# **Safety Evaluation Report**

related to the operation of  
Fermi-2

Docket No. 50-341

Detroit Edison Company, et al.

Figure 2-1

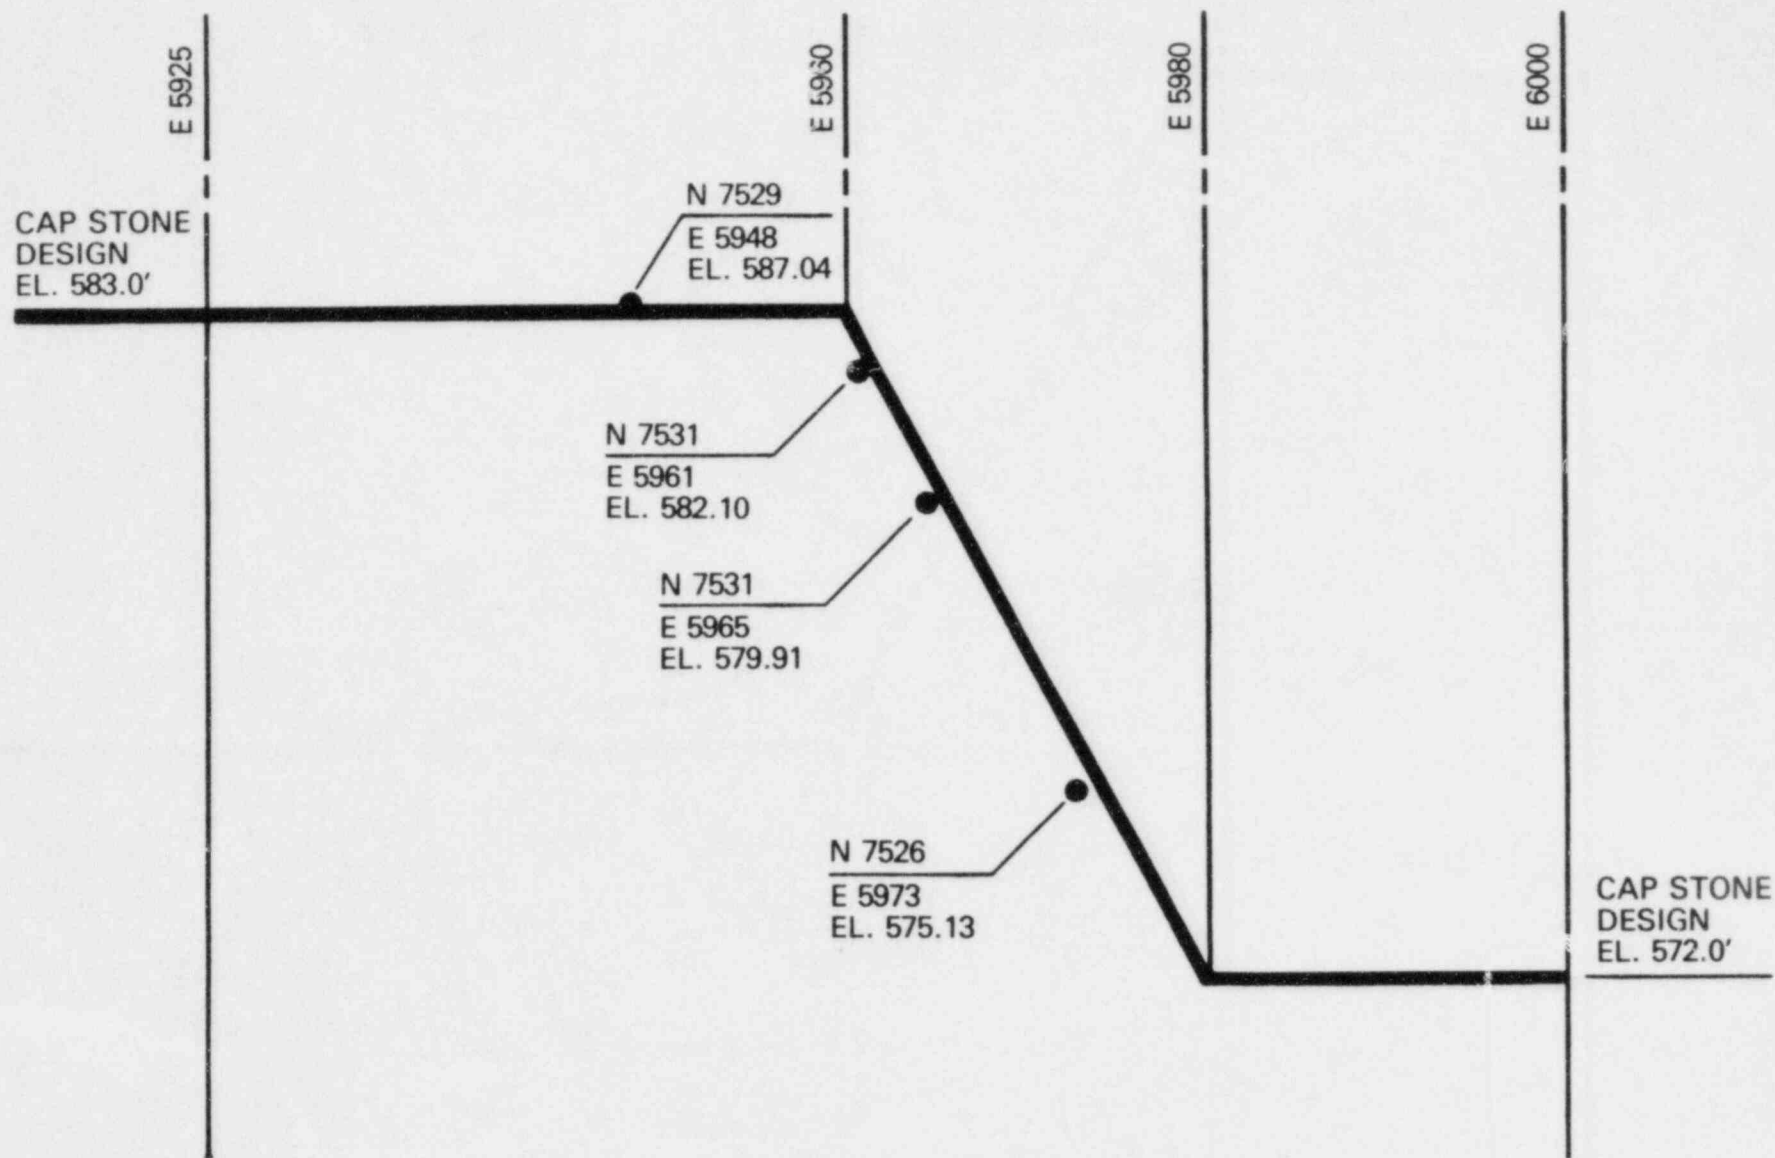
The shore barrier design profile requires a 35-foot crest width at elevation 583.0, then a 1 on 2 slope from 583.0 to 570.0, then a 20-foot section at elevation 572.0. Figures 2-1 and 2-2 show examples of the as-built profiles from the December 1984 survey. Figure 2-1 shows the best as-built section while Figure 2-2 shows the most deviation of the as-built structure from the design profile. We note that for this type of structure and considering the rock sizes used, it is difficult to construct the entire length of the structure to close tolerances. We further note that a tolerance of 6 to 12 inches is a normal deviation for a structure of this type. The Fermi-2 construction specifications required a tolerance of  $\pm 6$  inches. The applicant's position on this matter is that it was difficult to change from a one-capstone thickness between stations E5925 and E5960 to a two-capstone thickness between stations E5960 and E5980. While we cannot conclude whether the observed deviations are due to poor construction or minor settlement, our review of the construction photographs and the as-built surveys indicate that the shore barrier was probably constructed in its present configuration and that the observed deviations did not occur after construction. We conclude that the as-built shape of the shore barrier is satisfactory and will not impair its intended function. (Refer to Section 2.5.5 of this supplement for our evaluation of the filtering capability of the shore barrier.)
